**WARRANTY  
BULLETIN**

Wb98-24

DATE : June 1998	SECTION : 06
SUBJECT : INSTALLATION OF A DIODE ON R-4 RELAY

FIGURE 1, REAR JUNCTION BOX

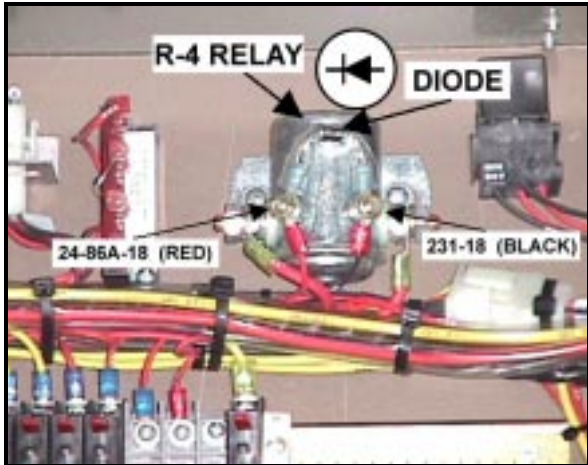
Without the addition of a diode on R-4 relay, the starter motor might activate twice with a single turn of the key.

1. Locate and open the rear junction box in the engine compartment.
2. Locate the R-4 relay in the upper right area of the junction box.
3. Secure the diode (Fig. 2) to the front terminals of the relay (Fig. 1) using the existent nuts.

**Note :** Ensure the diode is installed properly (gray indicating band to the red 24-86A-18 wire, the other side to the black 231-18 wire) (Fig. 1).
